REMARKS

Claims 7-14 were examined in the Office Action mailed July 13, 2005.

Amendments to the Drawings:

Fig.1

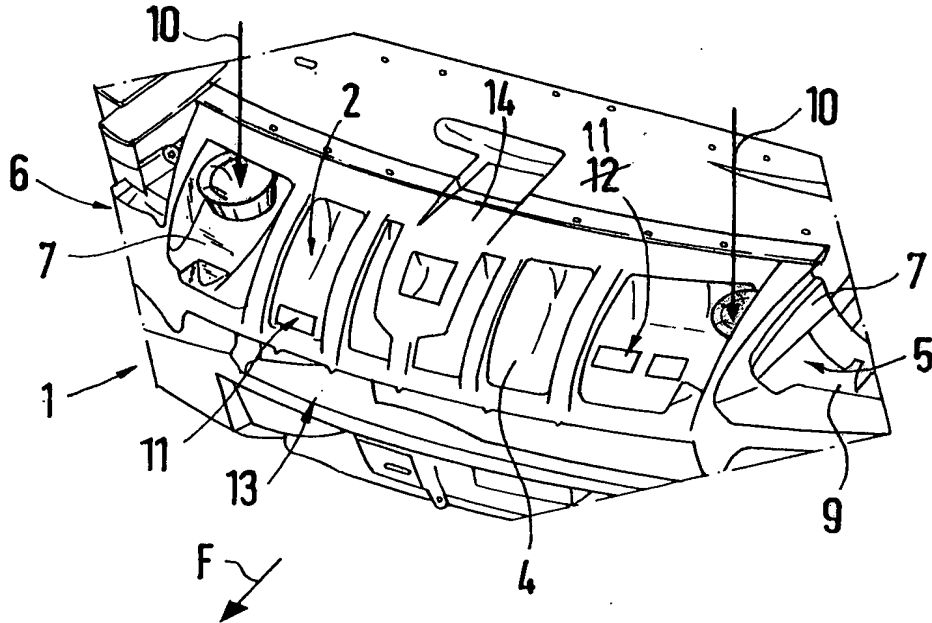
- At page 4, the Specification identifies "outlet opening 12" as the opening of intake stub 9. At page 5, the third full paragraph has been amended to clarify that the openings 12 are the previously recited "outlet openings 12." As a related matter, the Applicants noted that some of the air intake openings 11 were mis-labeled in Fig. 1 as "12." The Applicants have enclosed a proposed drawing change to correct the label to read "11."
- As to the labels 11 and 13 designating "air intake openings," the Applicants respectfully submit that no drawing changes are needed, as the Specification unambiguously introduces each set of openings 11 and 13 as openings in different components, *i.e.*, openings 11 *of separating partition 4*, and openings 13 *of forward section piece 3*. See Specification, paragraph bridging pages 4-5.

- The first full paragraph on Specification page 5 has been amended to replace the reference to correct the bearing part reference label from 14 to "4," as shown in Fig. 1.

The Applicants have attached hereto for Examiner approval a REPLACEMENT SHEET containing a proposed change to Fig. 1 to correct the reference label "12" to "11." A red-ink markup of the proposed change is also attached hereto.
